CITY PROJECT # 07-24

PALM SPRINGS ANIMAL CARE FACILITY

ADDENDUM NO. 2

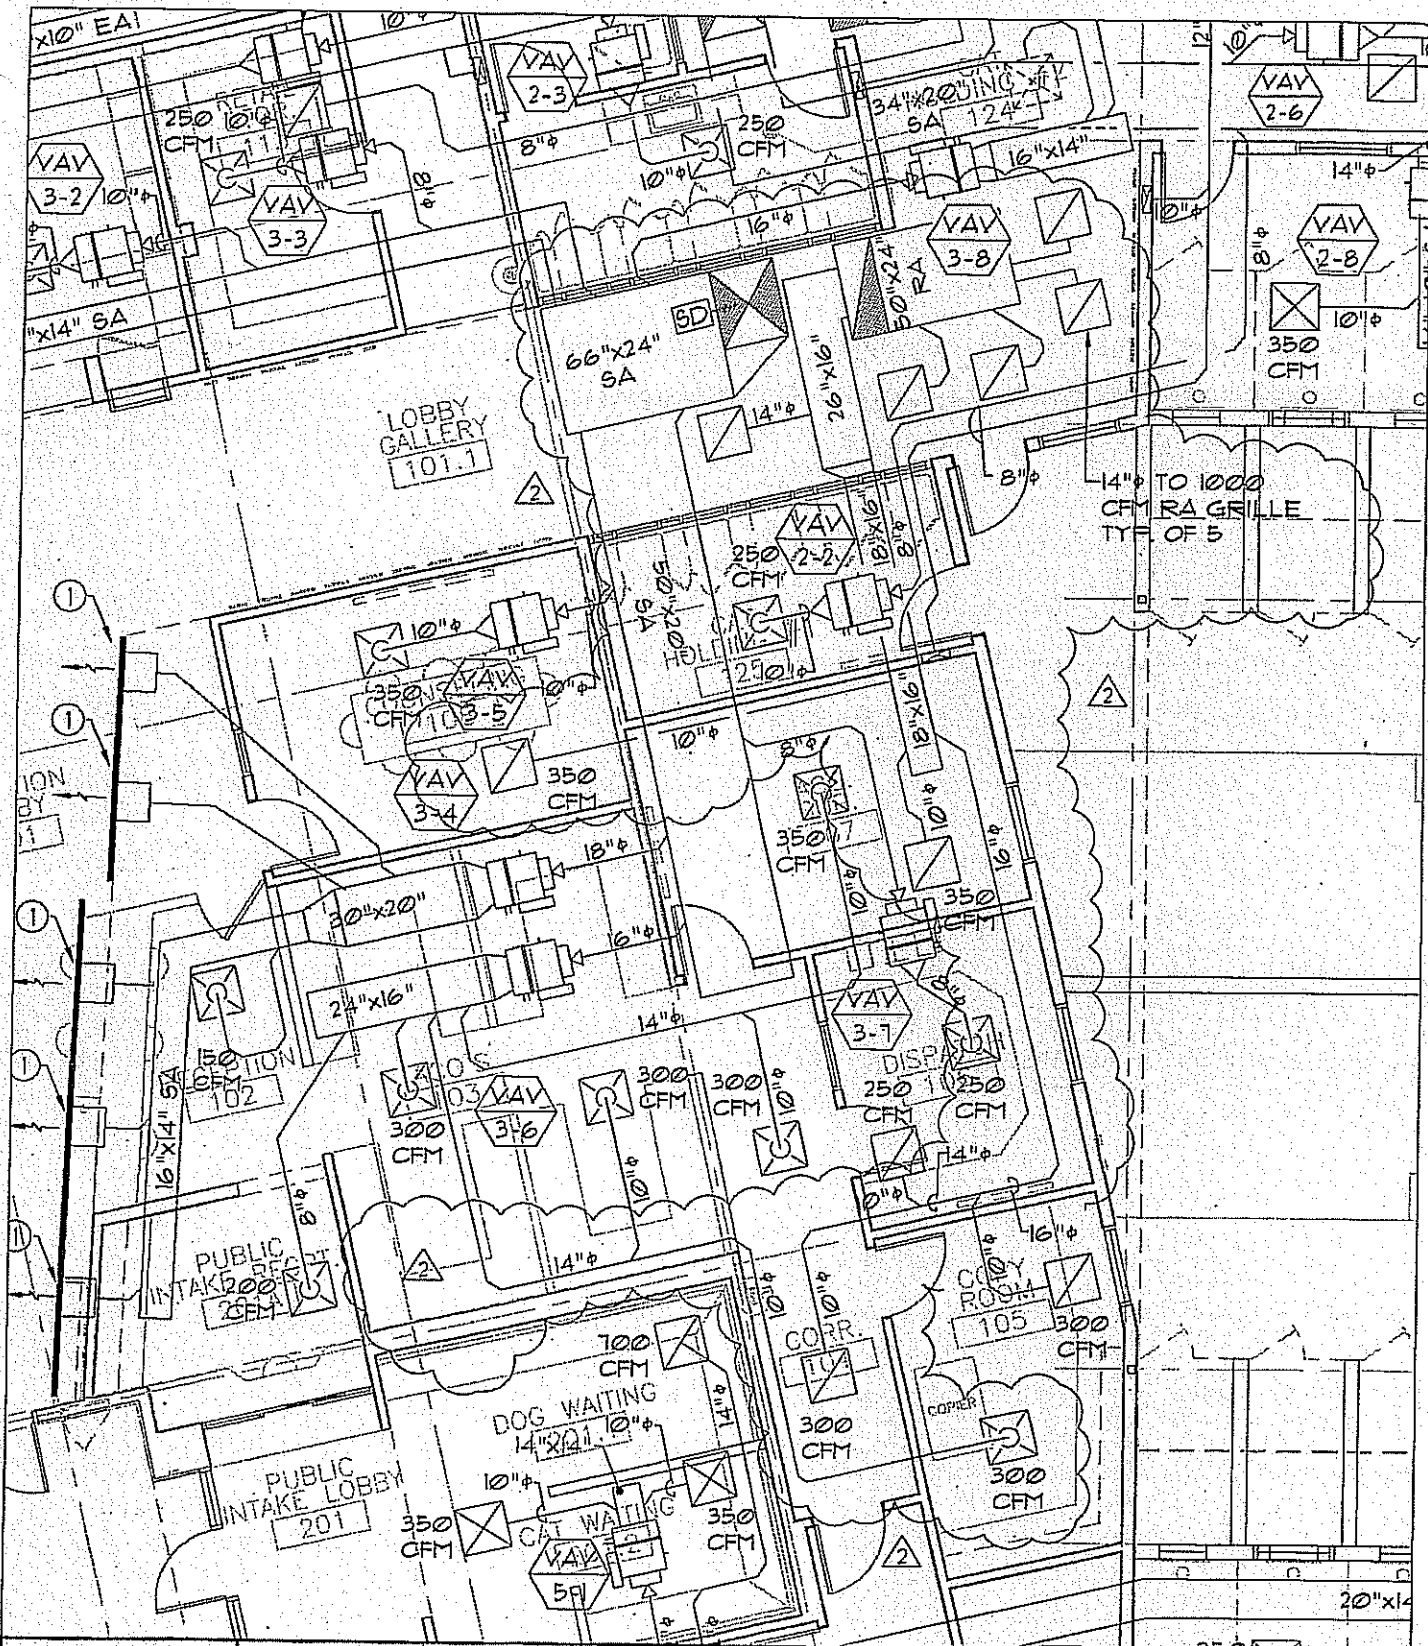
A2-M1: (Reference Drawing No. M2.1)
Revised Duct Work as Noted.

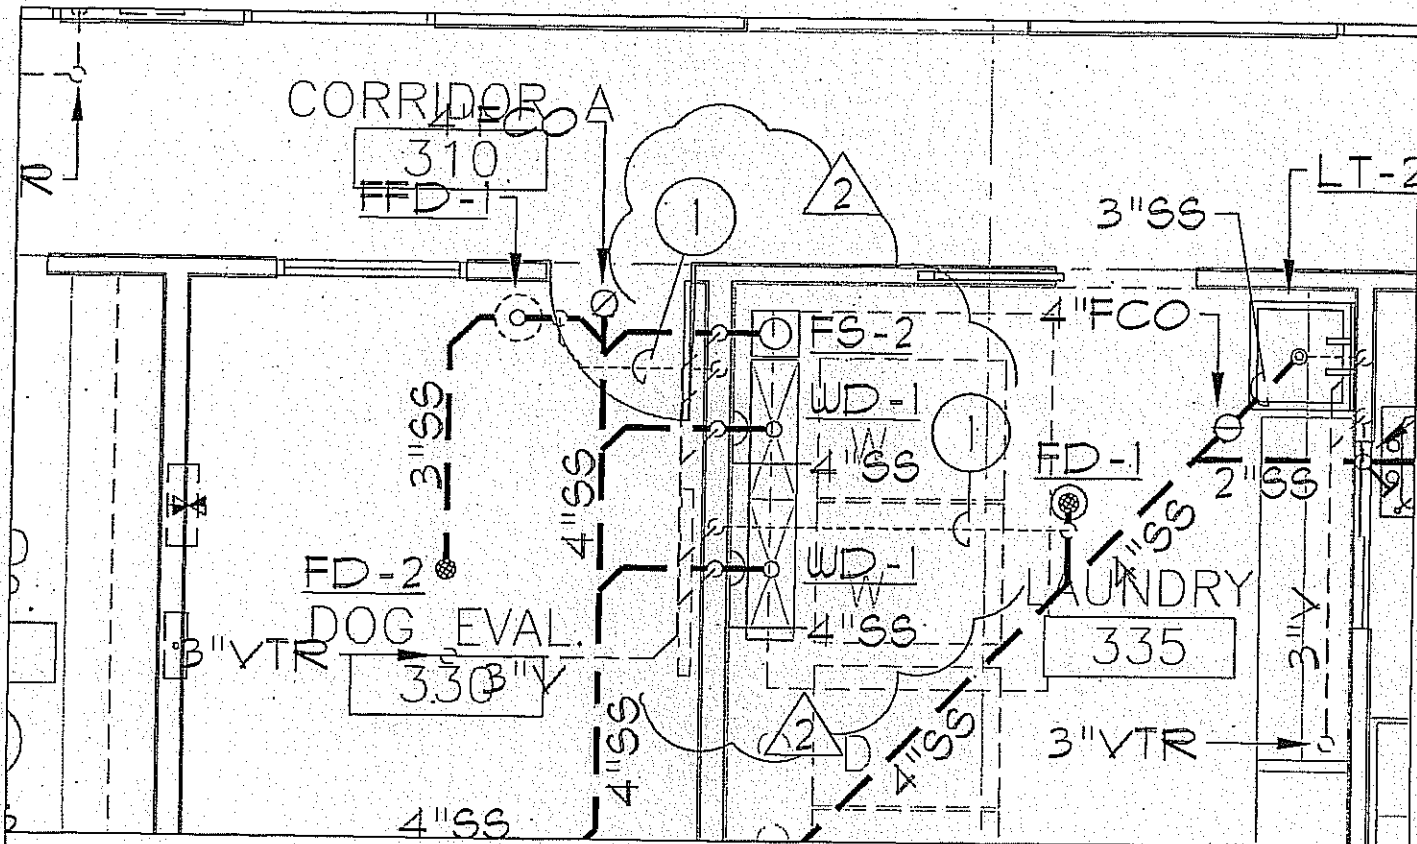
Revise the FS-2 floor sinks serving the washing machines at Laundry Room 335 to a trench drain type fixture.

A2-P2

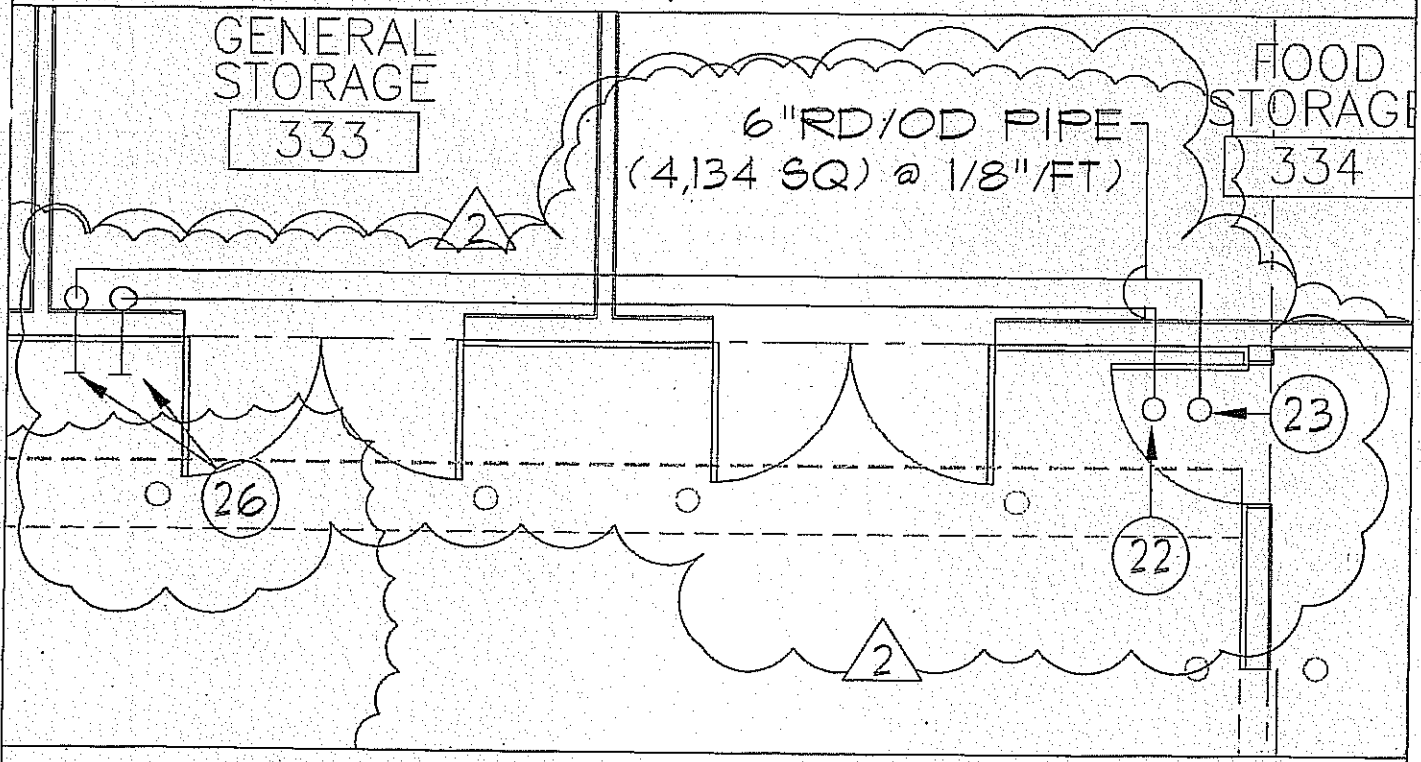
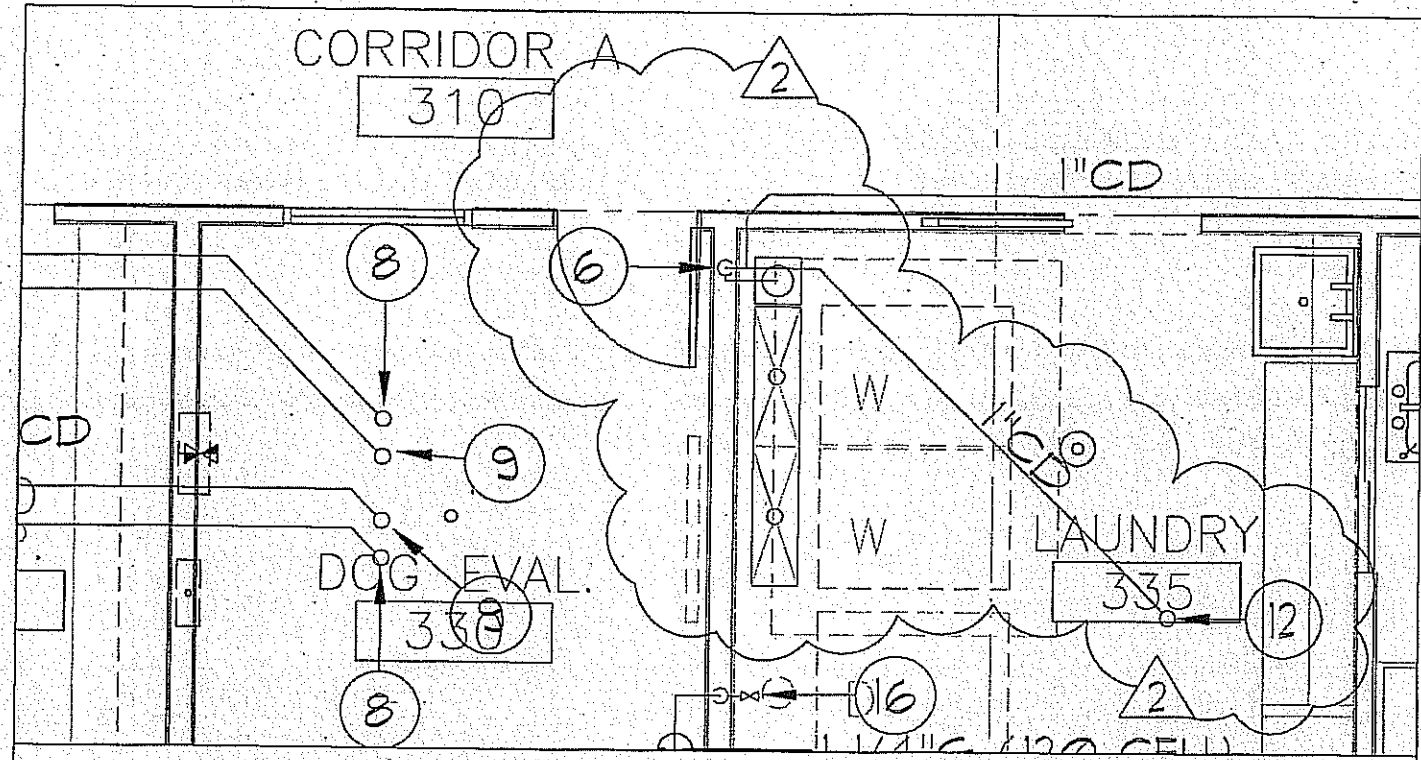
Revised CW, HW and RW Plan at Laundry Room 335.

A2-L1

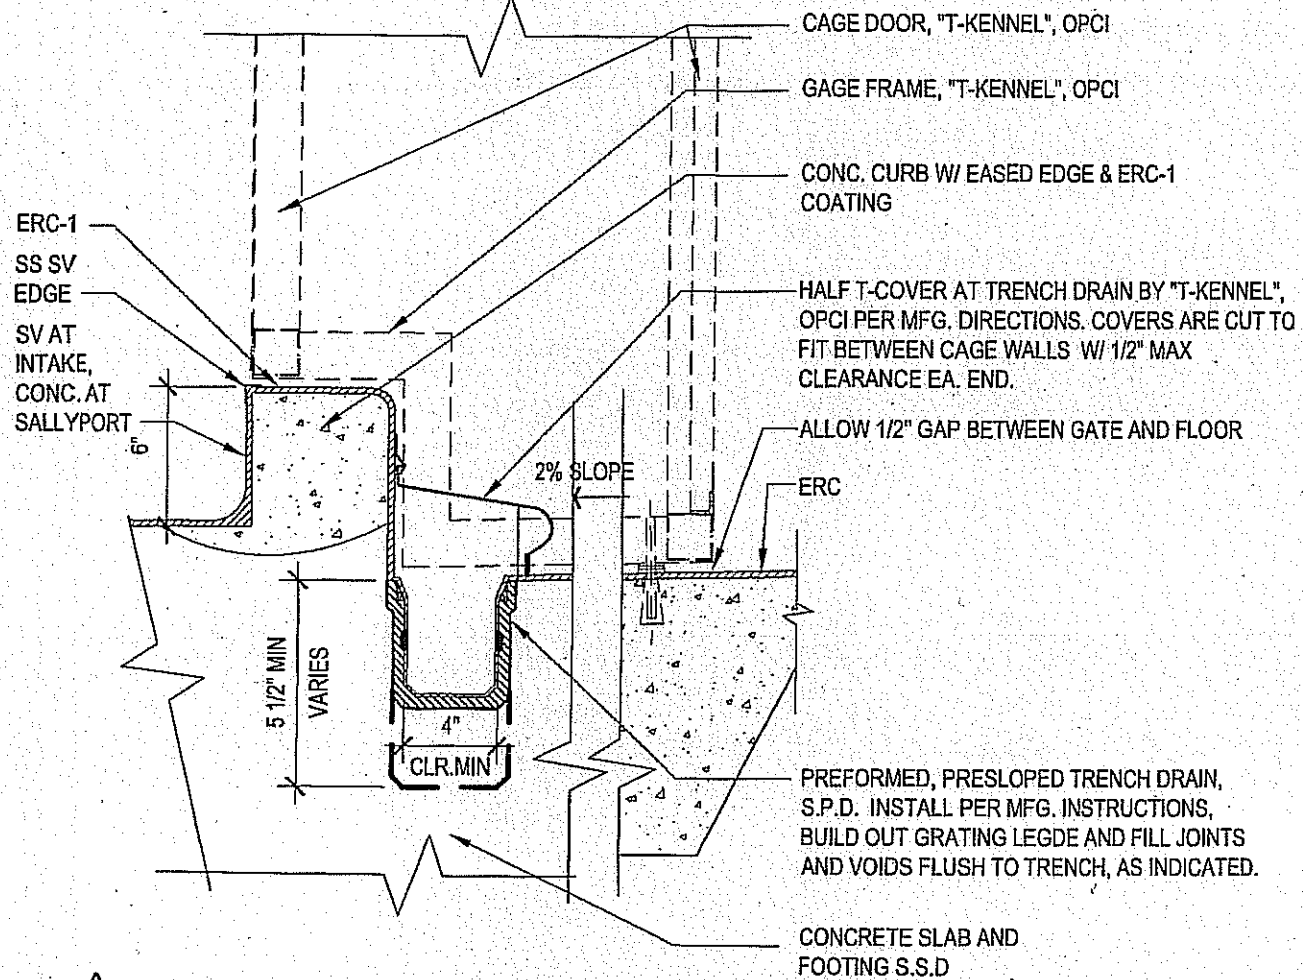
A2-L1: At Location Noted: enhanced concrete pavers have been changed to permeable concrete pavers. Callouts changed: P3 to P8 and P4 to P9 per this location only.

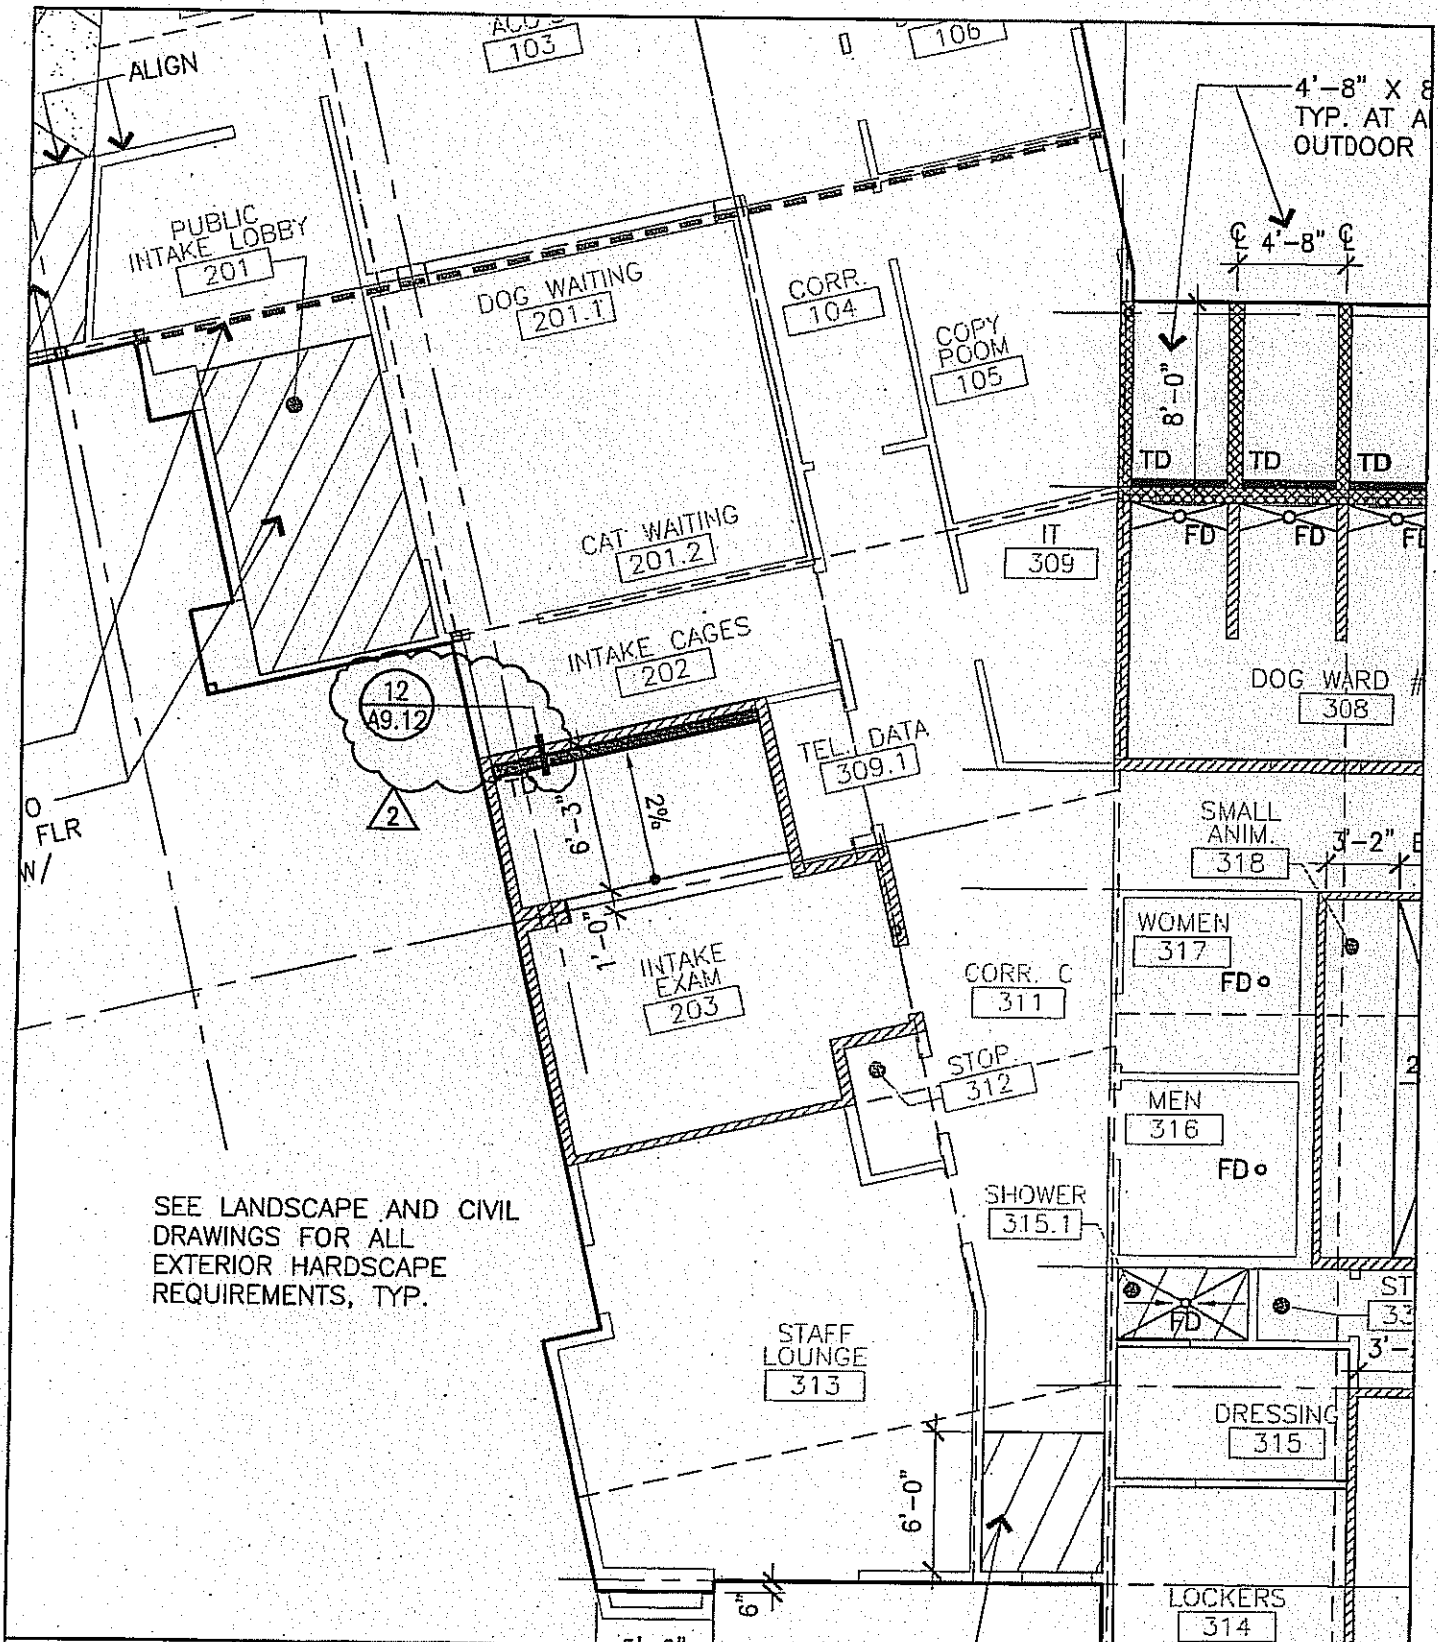
3. Reference: Architectural Drawing Sheet A9.12, Interior Details, Detail 8, Concrete Curb With ERC Finish At Animal Holding Rooms Typ.: Please show where this is located on floor plan. Where are the animal holding rooms? Please clarify.

A2-A1 (Reference Drawings No. A9.12):
Added Curb and Trench Drain Detail 12 on A9.12

Relative to this specific detail “Animal Holding Rooms” are the Dog Wards Rooms No. 301-308, Iso Dog Rooms 346 – 352 at the guillotine doors and at the curb located at the opening between the Large Animal Holding Rooms 344 and 344A at the guillotine door. Curbs at the Registry cages #340 and Intake Cages #202 are similar.
